Reference: Coastal Storm Risk Management Study Draft Integrated Feasibility Report and Environmental Assessment

This letter provides comments from Fairfax County, Virginia regarding the Coastal Storm Risk Management Study Draft Integrated Feasibility Report and Environmental Assessment dated May 2022. Responses were coordinated with the Fairfax County Departments of Planning and Development, Public Works and Environmental Services, and Transportation and the Park Authority.

Proposed Tentatively Selected Plan- Alternative 8 Belle Haven Floodwall and Levee

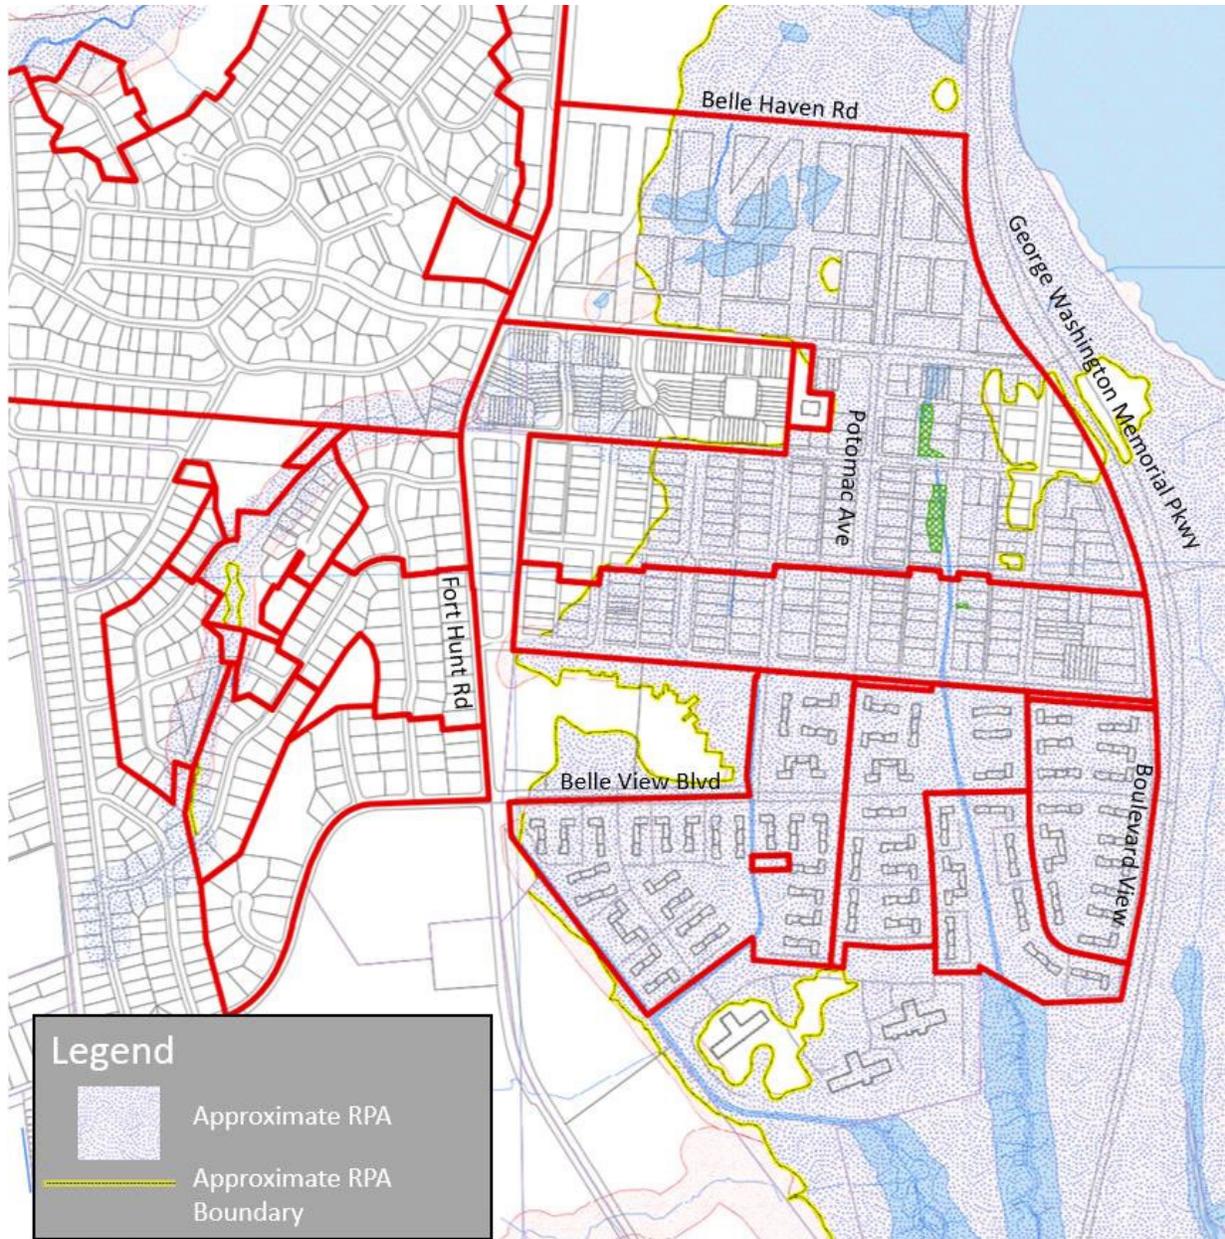
- Staff notes that the proposal may negatively impact the George Washington Memorial Parkway, which would be located on the river side (to the east) of the proposed flood walls. Staff recommends that future environmental analysis of the project consider locations both to the east and west of the George Washington Memorial Parkway for the

- Figure E-3 in the draft IFR/EA shows the proposed floodwall terminating at the northern end adjacent to the existing F Street Wastewater Pumping Station and the levee at the southern end terminating at the existing River Towers Wastewater Pump Station. The design should ensure that the floodwall and levee do not create adverse conditions that could impede normal operations or otherwise impact the existing wastewater pump stations.

The provided documents show the southern end of an earthen levee extending into Westgrove Park. Westgrove Park will experience direct impacts of lost land, recreation facilities, vegetation, and habitat, increased storm water discharge, invasive species, as well as wildlife habitat quality impacts. Therefore, FCPA staff would like to review all future documents and plans at the earliest opportunity as the project progresses. Additionally, the FCPA requests the opportunity to review the future submission of the Section 106 of the National Historic Preservation Act consultation as it progresses.
